REGIONAL REVIEW NOTICE

Name of Proposal: Abernathy Road/Glenridge Drive Development

SUBJECT: **Transportation Division Review of DRI # 2494**

6615 AND 6565 GLENRIDGE DRIVE (MERCEDES HEADQUARTERS) DRI
City of Sandy Springs
Natural Resources Division Review Comments
May 20, 2015

SHEET 1 04/06/15	DUANY PLATER-ZYBERK & CO. ARCHITECTS AND TOWN PLANNERS 1023 SW 25TH AVE, MIAMI FL 33135 P. 305.644.1023 F. 305.644.1021
------------------------	--

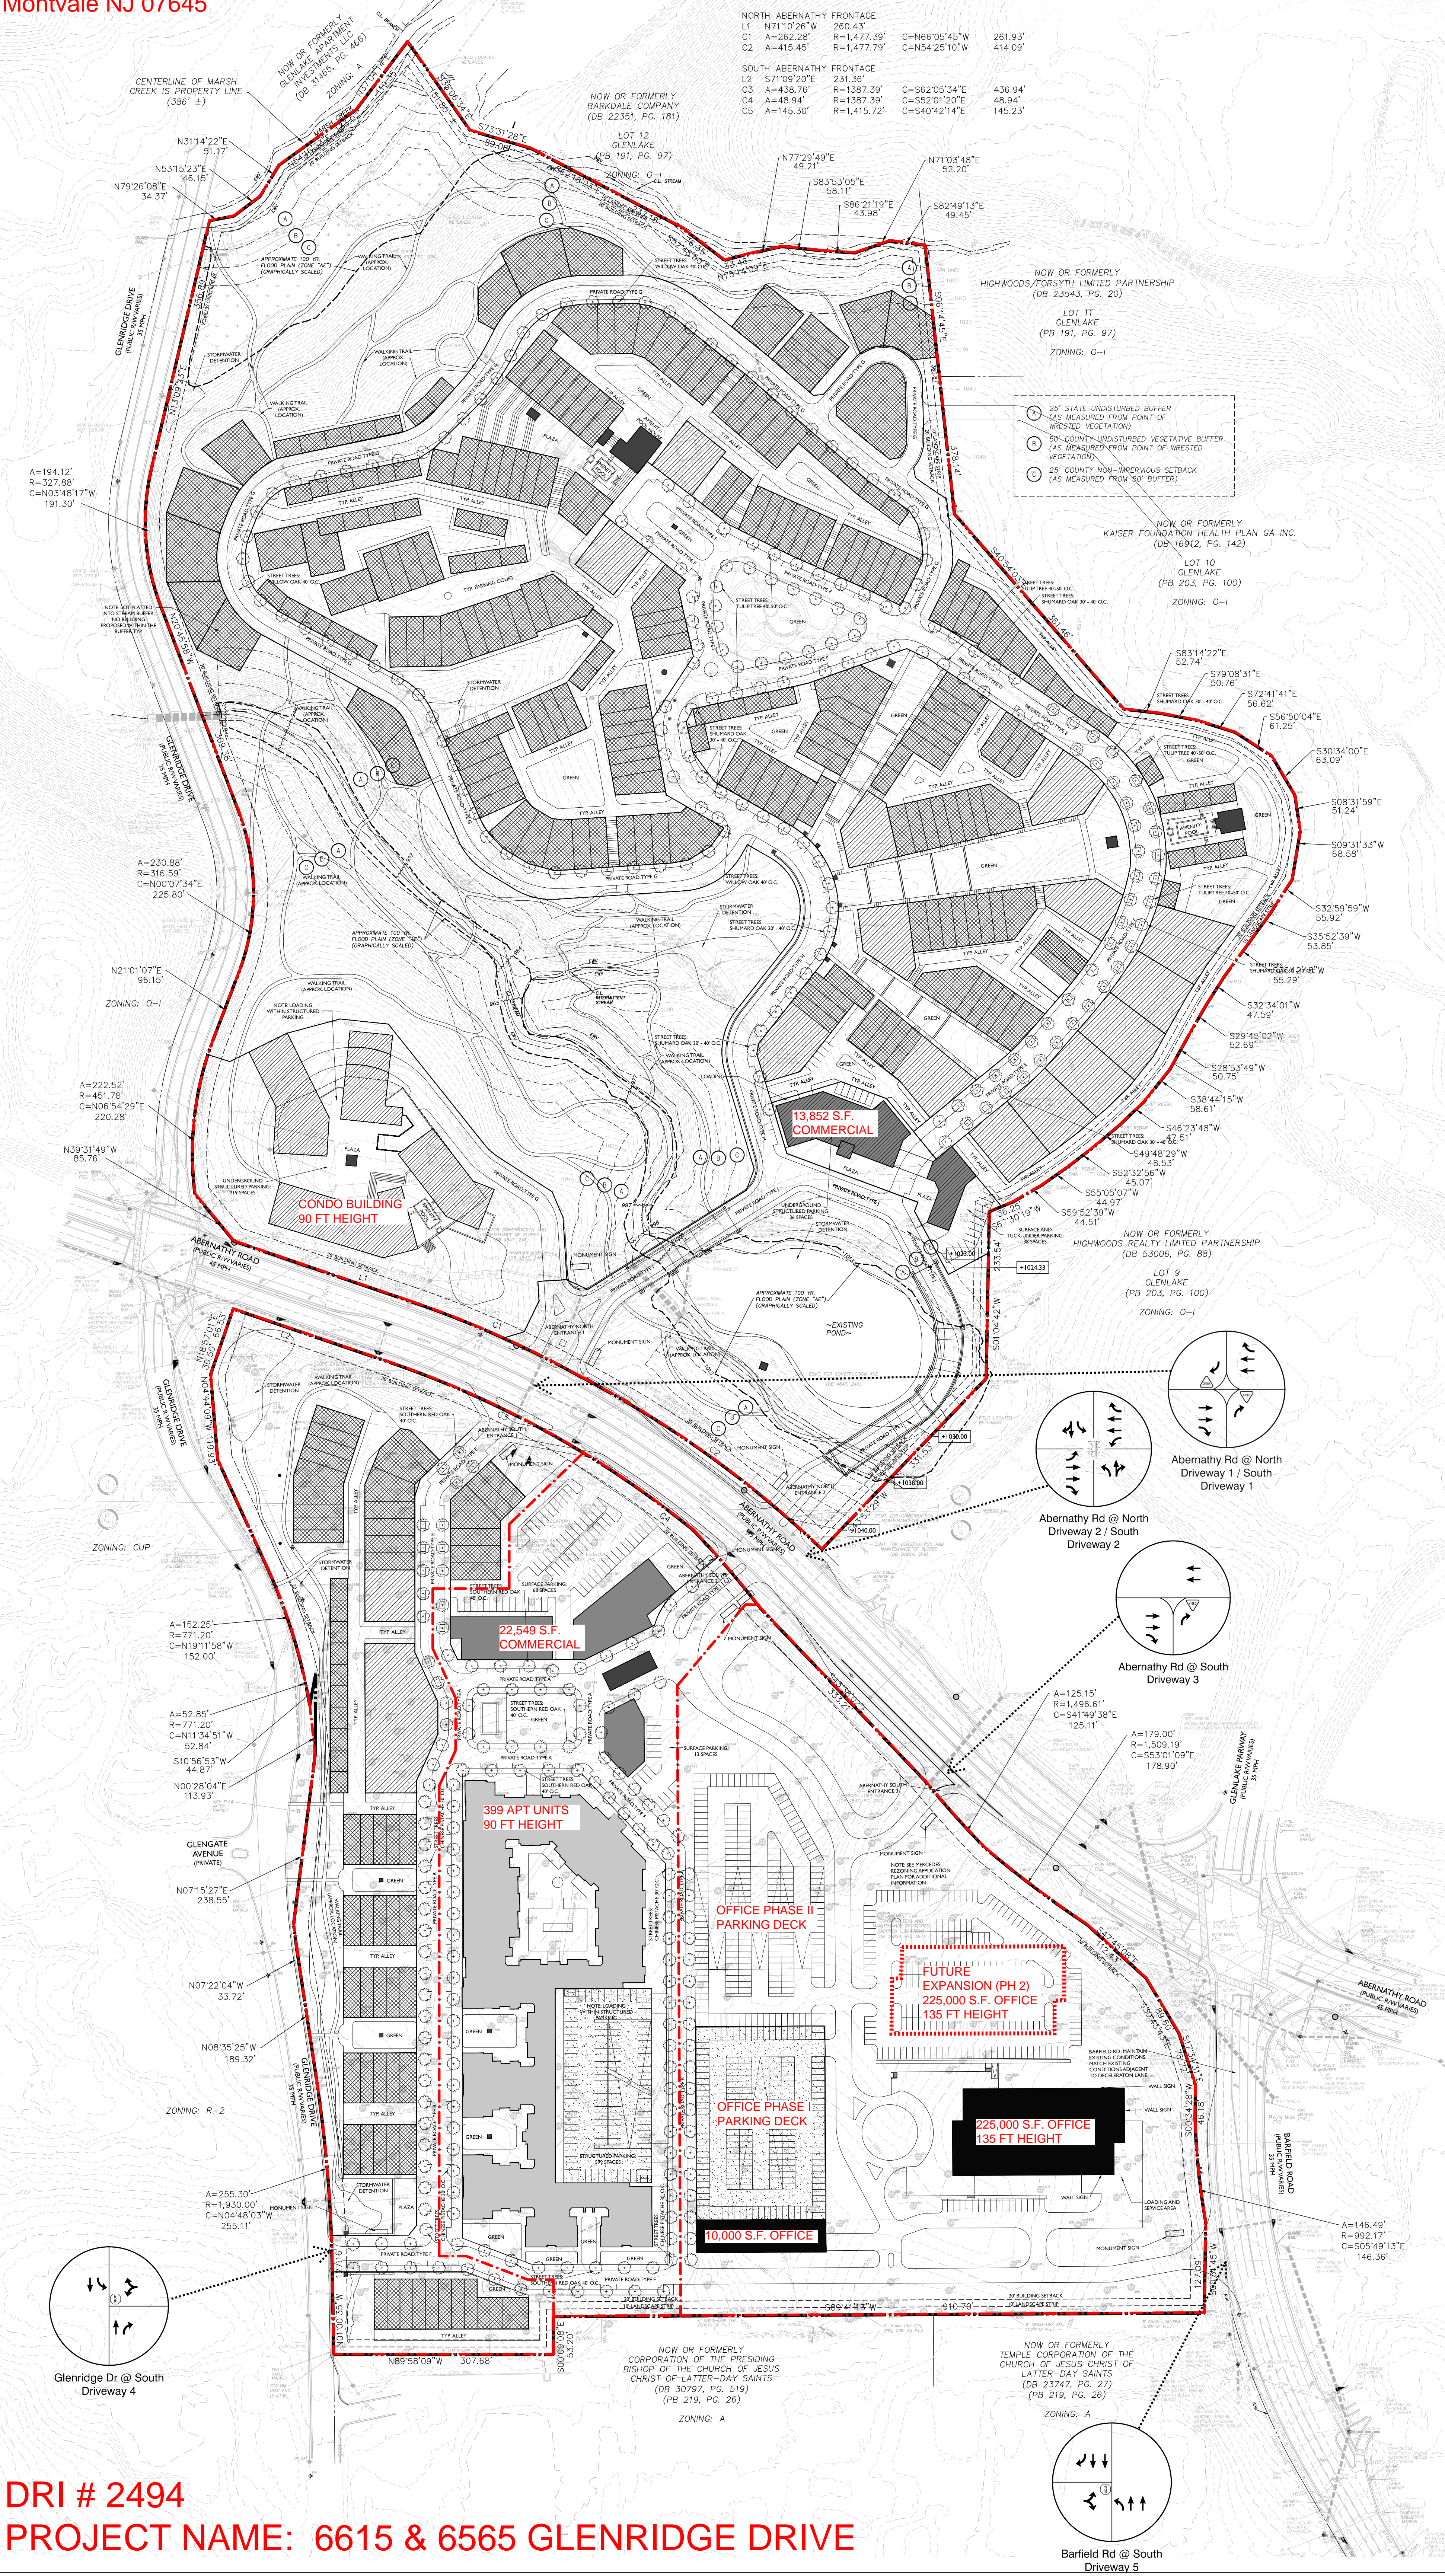
The south site has five access points, including three access points on Abernathy Road, one on Glenridge Drive, and one on Barfield Road. The north site only has two access points, both on Abernathy Road. This necessitates all traffic generated by the north site to use Abernathy Road, a corridor that already has heavy traffic congestion.

During the pre-review meeting for this DRI, adding an additional access point to the north site from Glenridge Drive was discussed. The developer's consultant identified topography as a potential limiting factor to prevent this access point. Upon review of the traffic study and site plan:

- The site plan includes topo, which shows that Glenridge Drive changes elevation at a comparable grade to the adjacent west side of the site.

- The site plan shows a walking trail connecting from the site to Glenridge Drive at two locations. If two trail connections are feasible with the site's topo, then a roadway connection should also be feasible.

Preserving a location for potential connectivity to the adjacent parcel on the east side of this site was also discussed at the DRI pre-review meeting. It appears that a location for this is shown on the site plan on the northeast edge of the parcel. This location should be clearly labeled as being preserved for future adjacent parcel access.

The site plan identifies the roadways on both sites as private roads. If any roads or parking facilities have gated access, the roadways at the site entrances shall provide adequate queuing space on the approaches to the gates to prevent vehicle queues from extending onto the adjacent roadways.

Bike and pedestrian facilities that will be constructed along adjacent roadways should be clearly identified on the site plan. Additionally, the traffic study states that the City of Sandy Springs “Bicycle, Pedestrian and Trail Implementation Plan” makes a number of recommendations in the vicinity of the site. Recommendations for facilities along public street frontages adjacent to the site should be constructed as a part of the development. The applicant should coordinate with the City of Sandy Springs to ensure implementation of these facilities is consistent with the existing plans.
